CHEVRON U.S.A. INC.

Attached plot and data table shows step rate test data that I discussed with you yesterday. I have also attached a copy of the disposal permit and a wellbore diagram.

ADMINISTRATIVE ORDER SWD-659

From: Catanach, David
Sent: Tuesday, July 17, 2001 2:15 PM
To: 'Joe Williams'
Subject: Step Rate Test

Step Rate Test Data

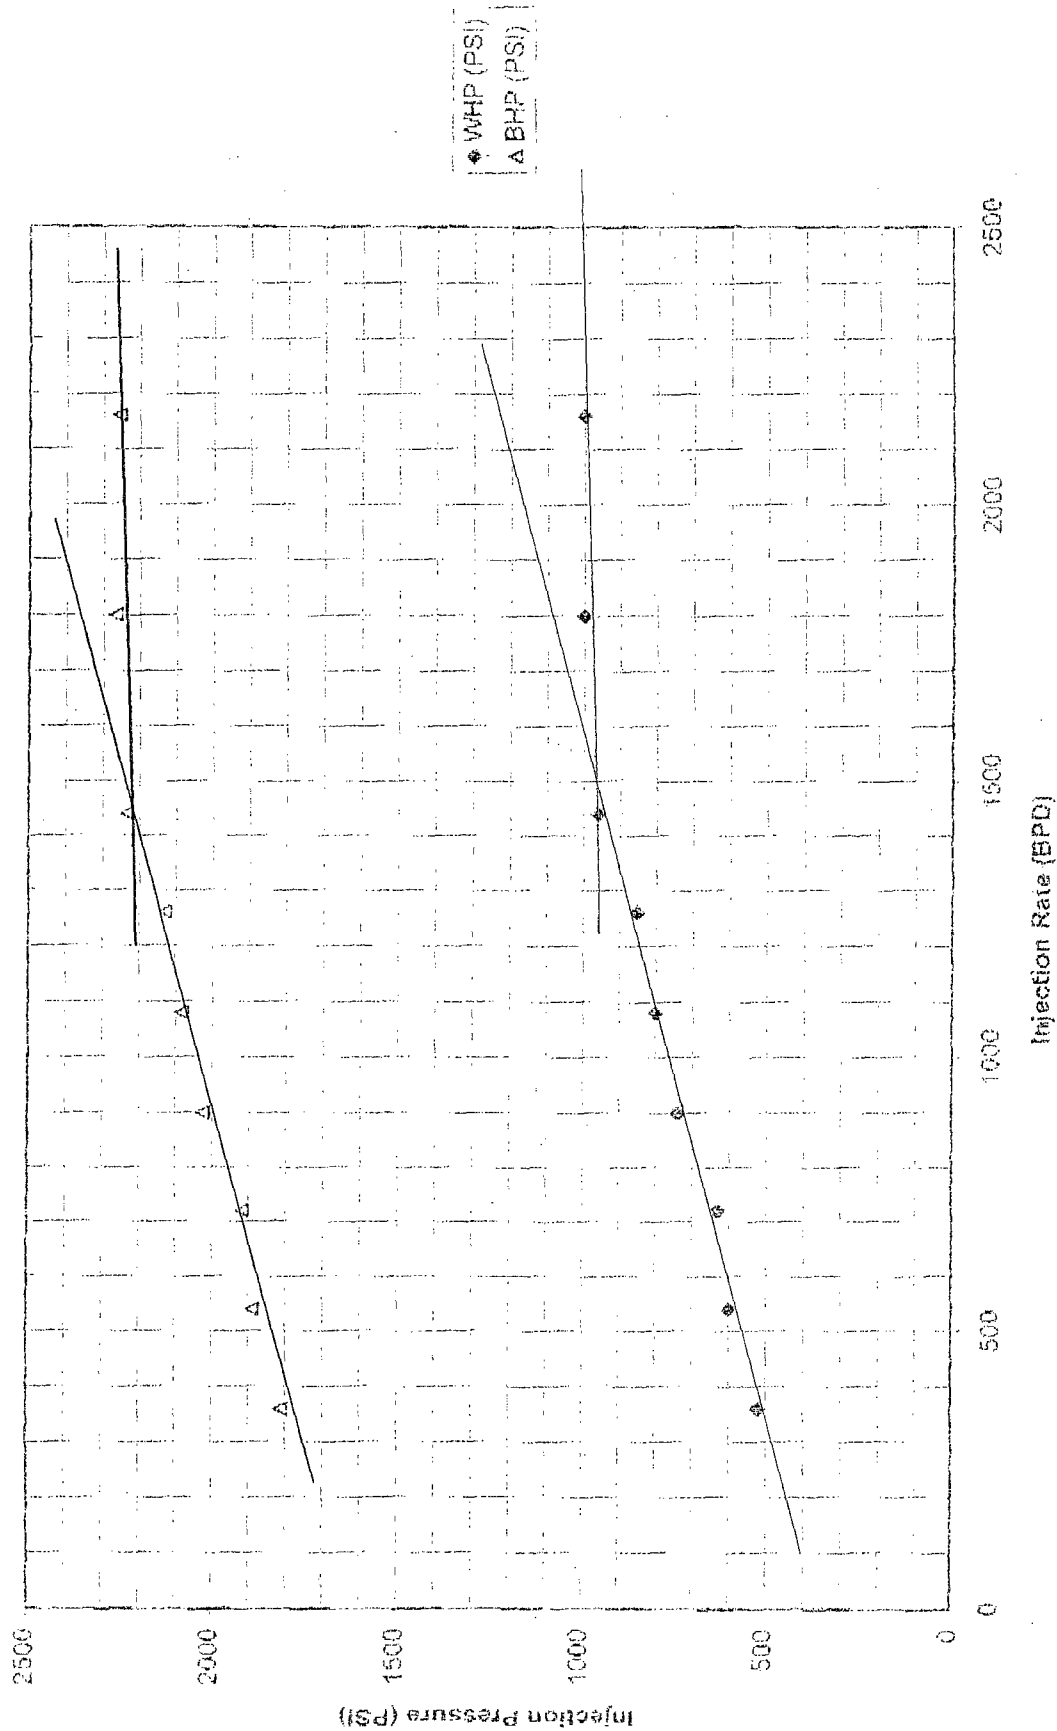
The well is equipped with 2-7/8" tubing to 2814'. The data table shows measured injection rates and wellhead pressures (WHP) and calculated friction losses and bottom hole pressures (BHP). The measured WHP and calculated BHP are plotted.

It appears that the formation parting occurs at a WHP of 1000 psi and a calculated BHP of 2260 psi at a rate of 1800 BPD. The calculated frac gradient to the middle of the perforated interval at 2957' is 0.76 psi/ft.

Chevron proposes to increase the permitted wellhead injection pressure from 600 psi to 800 psi. This would correspond to a calculated bottom hole pressure of 2083 psi or a gradient of 0.70 psi/ft to mid perf. The proposed pressure increase would allow Chevron to dispose of all lease produced water in this well.

Joe, I have not yet issued an order approving the pressure increase, however, the test looks good and you will not have to re-run it. I'll get your increase just as soon as I can.

Step Rate Test Data

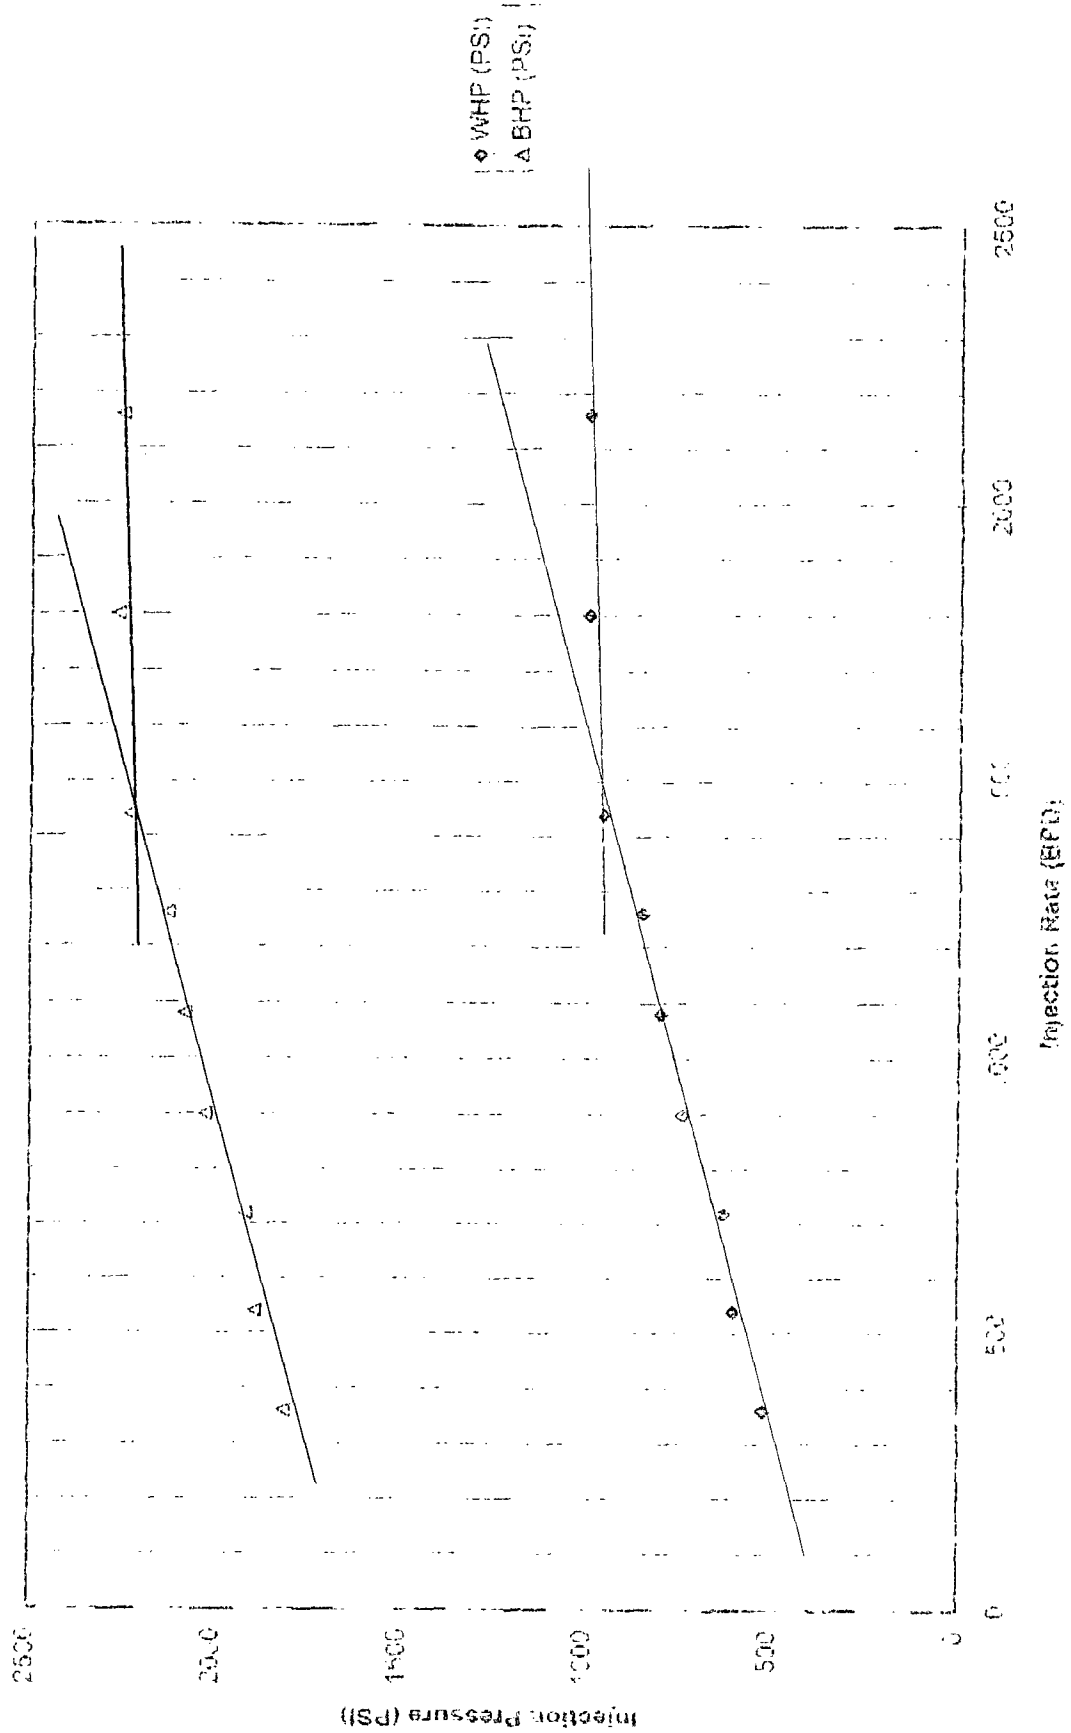
The well is equipped with 2-7/8" tubing to 2814'. The data table shows measured injection rates and wellhead pressures (WHP) and calculated friction losses and bottom hole pressures (BHP). The measured WHP and calculated BHP are plotted.

It appears that the formation parting occurs at a WHP of 1000 psi and a calculated BHP of 2260 psi at a rate of 1800 BPD. The calculated frac gradient to the middle of the perforated interval at 2957' is 0.76 psi/ft.

Chevron proposes to increase the permitted wellhead injection pressure from 600 psi to 800 psi. This would correspond to a calculated bottom hole pressure of 2083 psi or a gradient of 0.70 psi/ft to mid perf. The proposed pressure increase would allow Chevron to dispose of all lease produced water in this well.
